Dometic Gateway

CC RV-C Gateway
Service Bulletin

In the Complaint section note: KSB # 181206

Blizzard NXT

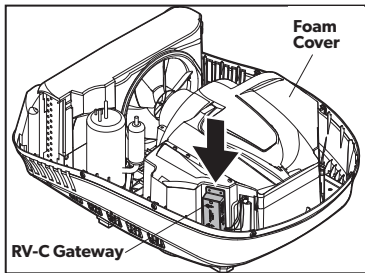
1. Locate the CC RV-C Gateway near the AC, through the Plenum, or remove the AC shroud.
2. Remove the two strips of foam mounting tape.
3. Unplug the harness from the CC RV-C Gateway and remove the CC RV-C Gateway.
4. Verify the replacement CC RV-C Gateway box shows the correct replacement part#’s (see page 1).
5. Attach the harness to the new CC RV-C Gateway.
6. Apply two strips of foam mounting tape to the replacement CC RV-C Gateway and position in the AC (see suggested mounting locations below).
